**HISTORIC PRESERVATION REVIEW BOARD
STAFF REPORT AND RECOMMENDATION**

Landmark/District: **Mount Pleasant Historic District** (x) Consent calendar
Address: **1716 Kenyon Street NW**

Meeting Date: **September 18, 2014** (x) Addition(s)
Case Number: **14-639**

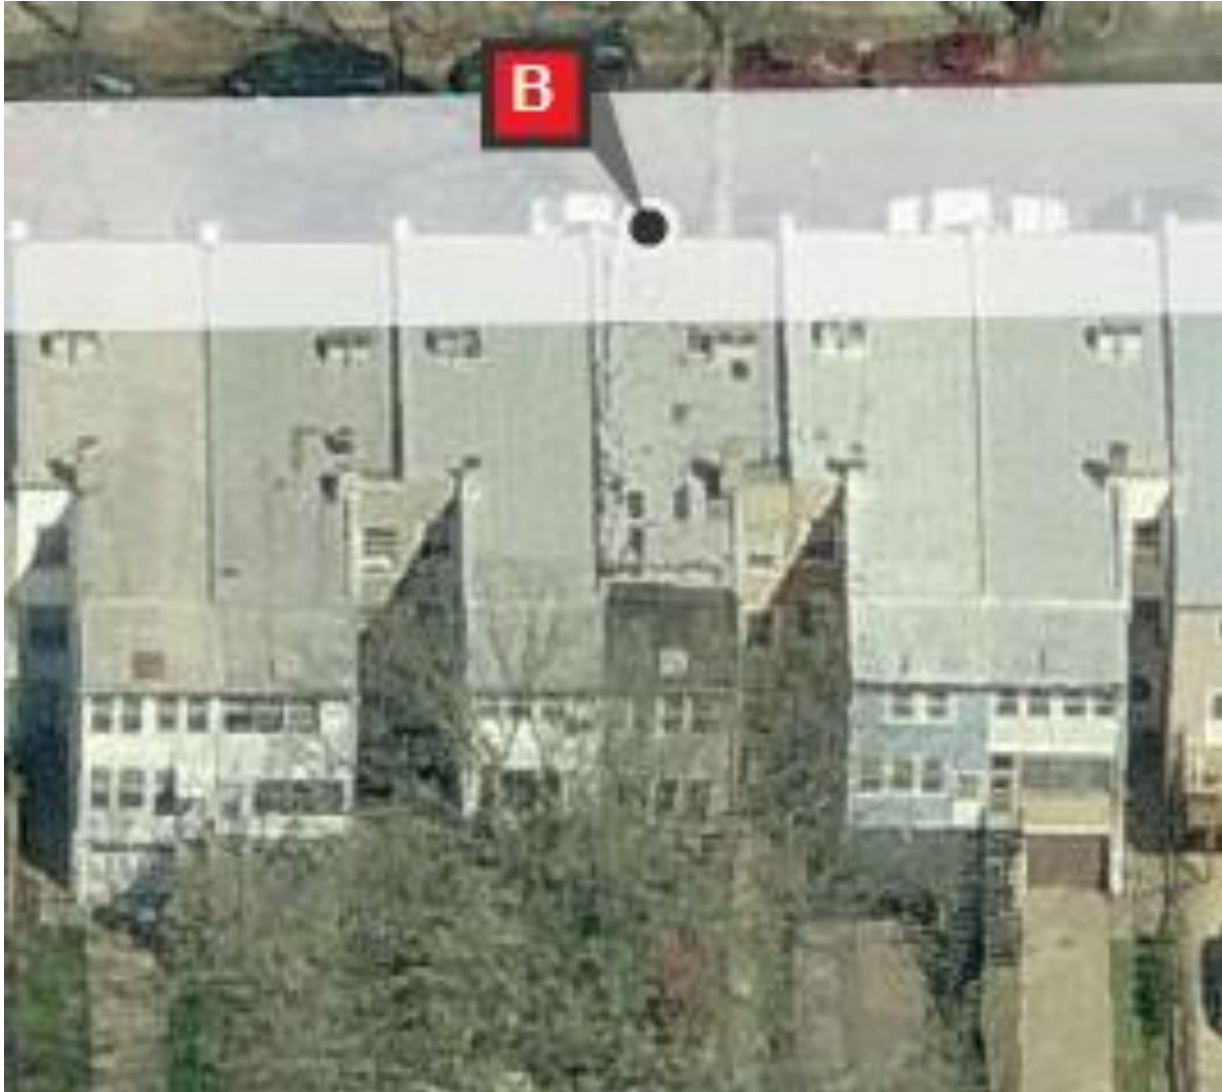
The concept calls for sloping the addition's roof upward from the existing ridge at the front double-pent roof in order to conceal the structure from view from the street, an approach that the Board has supported in several similar situations in Mount Pleasant and in other neighborhoods with similar house types. The section/sightline drawing on page 10 depicts the front roof inaccurately, as it shows the upper portion as vertical, which is not its present condition. This seems to be a mistake, but it should be clarified that this roof is *not* to be rebuilt, and the drawings should be revised accordingly. Also important to the success of an "invisible" addition is the detailing of the construction documents to minimize any necessary flashing or other drainage features that could be visible coming over the roof ridge to carry water down the front of the building. The added roof area may require additional gutter/downspout capacity.

A rooftop addition requires the extension upward of the side walls. Parapets extending above the walls are often favored by the code official for fire separation from adjacent properties, but roofing materials can be fire rated in order to eliminate such parapets. There should be no extension of the side parapets or firewalls that would be visible from Kenyon Street. The perspective on page 16 does not depict the stepped parapets quite as they are, but taller. This, too, is presumably an error and should be corrected for the purpose of construction drawings and to clarify that these walls are not actually being modified.

The addition would extend rearward to a point atop a portion of the reconstructed enclosed porch. However, this kind of roof addition has typically been approved with a few feet of setback forward of a rear wall of the wing, in order to preserve a sense of the original roofline along a row. Yet, when such rows have repeating two-story porches, the Board has permitted the addition to come to the masonry rear wall, i.e., the forward edge of the porch, so that the projection of the porch roofs alone retain the original rear roofline. This proposal does not quite achieve this, extending several feet onto the roof of the reconstructed enclosed. The rear wall of

the roof addition should then be pulled toward the street, so that it does not extend rearward of the masonry walls of the existing ell. This would provide more separation of the rooftop addition from the two-story mass of the rear addition/porch.

A couple other items, not shown in the drawings, could complicate further review. There is no indication of heating vents, plumbing stacks or mechanical vents and equipment on the new roof.

- *the addition not be visible from Kenyon Street, with a flag test to be performed and the final construction drawings to adhere to such a test;*
- *the front roof, roof ridge, side parapets, chimneys and rooftop mechanical (including vents and stacks) not be modified in a way that can be seen from Kenyon Street;*
- *the location of the rear wall of the roof addition be shifted a few feet forward so as not to extend rearward of the end of the masonry ell; and*
- *any other exterior work, including but not limited to window replacements, be detailed for staff review and permit clearance.*
